IN THE MATTER OF An application RM23.185 by Dunedin City Council for the continued operation and closure of the Green Island Landfill, Dunedin

**STATEMENT OF EVIDENCE OF DR LARICAR DOMINIC ORTEGA TRANI ON
BEHALF OF OTAGO REGIONAL COUNCIL**

21 FEBRUARY 2025

Figure 1. Plasticity chart

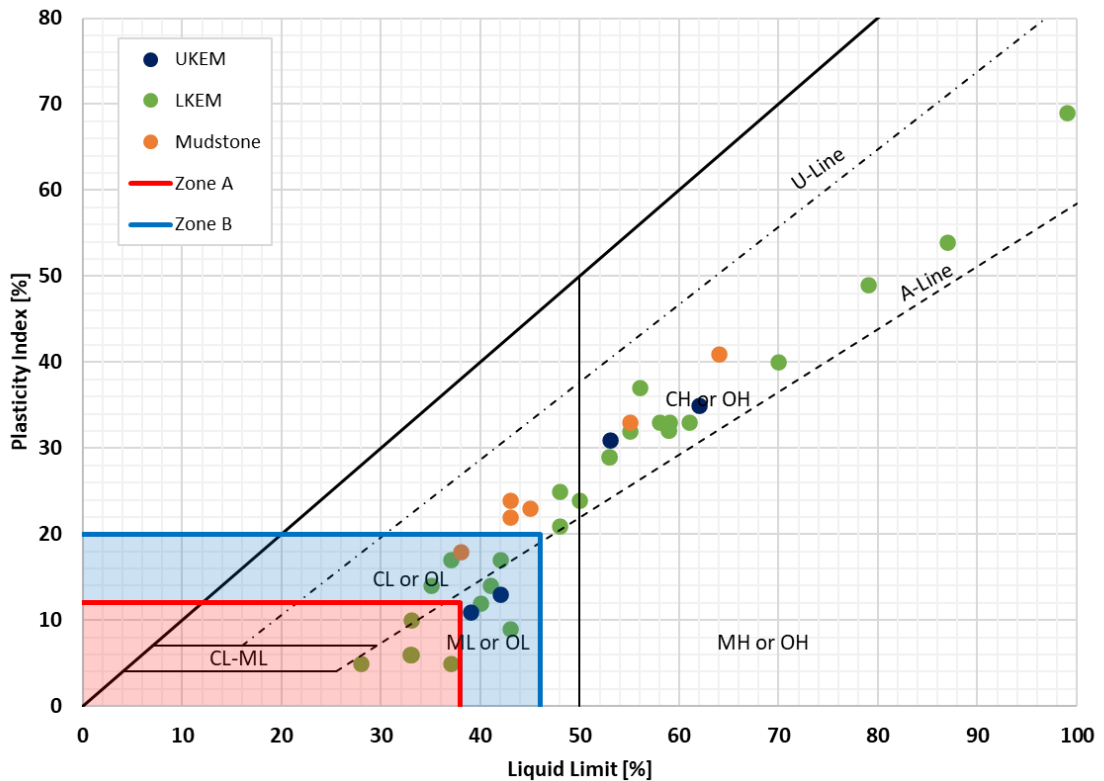
- 6.2 Liquefaction potential screening criteria has been included based on Seed et al., where Zone A soils (highlighted in red) are considered potentially susceptible to liquefaction. Zone B (highlighted in blue) may be susceptible to liquefaction. Soils plotting outside zone A and B are generally not considered to be susceptible to liquefaction triggering but may be sensitive.

- 6.4 Based on the Seed classification, a number of samples from both the UKEM and LKEM units reflect liquefaction susceptibility (Zone A and B). These samples have a higher level of sand content (sandy clay, sandy silty clay, sandy silt, silty sand).

- 6.5 The UKEM unit is predominantly characterised as generally 'sand like with occasional thin lenses of clay' while LKEM is generally 'clay like with occasional thin lenses of sand'. As a result, it is reasonable to assign the UKEM with a 'High' liquefaction susceptibility, and the LKEM unit with a 'Low' liquefaction susceptibility.
